## **Draft new UN Regulation on hydrogen-fuelled vehicles of categories L<sub>1</sub>, L<sub>2</sub>, L<sub>3</sub>, L<sub>4</sub> and L<sub>5</sub>**

### **Submitted by the expert from Japan**

The text reproduced below was prepared by the expert from Japan to establish a new UN Regulation for the safety-related performances of hydrogen-fuelled vehicles of categories L<sub>1</sub>, L<sub>2</sub>, L<sub>3</sub>, L<sub>4</sub> and L<sub>5</sub> as an outcome of incorporating comments from European Commission and some editorial modifications. It is based on GRSP-61-03 distributed without a symbol at the sixty-first session of the Working Party on Passive Safety (GRSP) (ECE/TRANS/WP.29/GRSP/61, para. 47). The modifications to GRSP-61-03 are marked in bold for new and strikethrough for deleted characters.

**Figure 1**

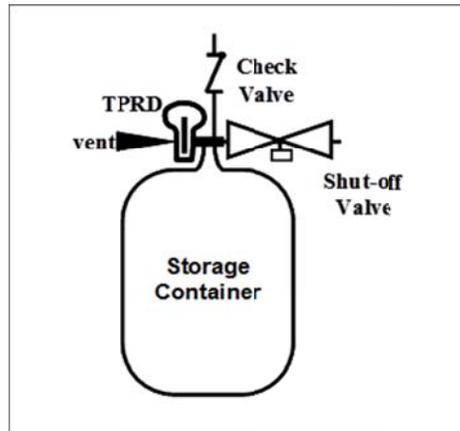
**A container shall be metal liner reinforced with resin impregnated continuous filament (fully wrapped) and a water capacity of 23 litres or less.**

All new compressed hydrogen storage systems produced for on-road vehicle service shall have a NWP of 70 MPa or less, a service life of 15 years or less; ~~a water capacity of 23 litres or less~~ and be capable of satisfying the requirements of paragraph 5.

**Figure 2**

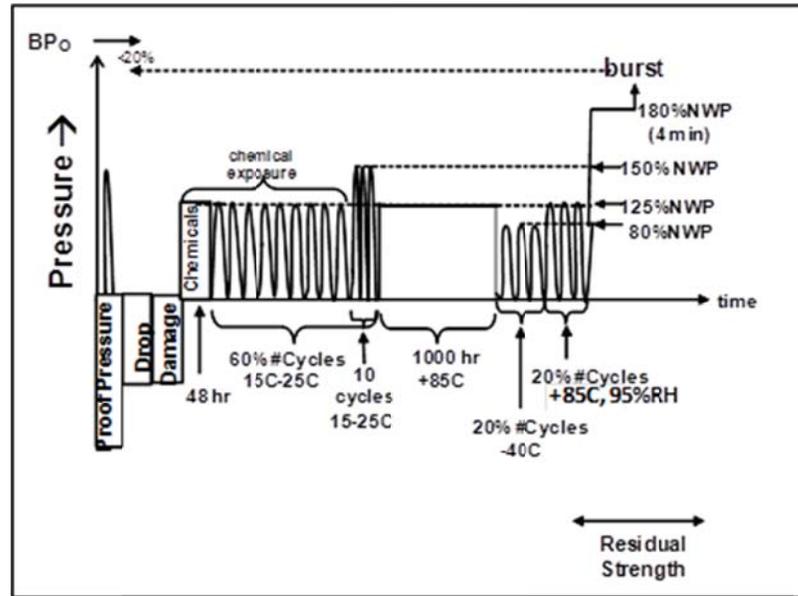
5.2.7. ~~Hydraulic residual pressure test~~ **Residual proof pressure test**

5.2.8. Residual ~~burst~~ strength **burst** test

Figure 3

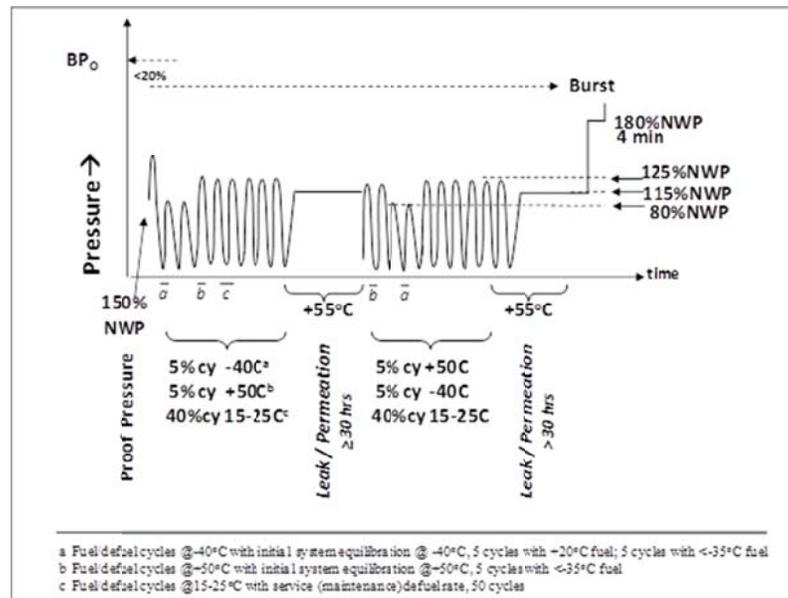
5.3.3. Extreme temperature static **gas** pressure leak/permeation test.
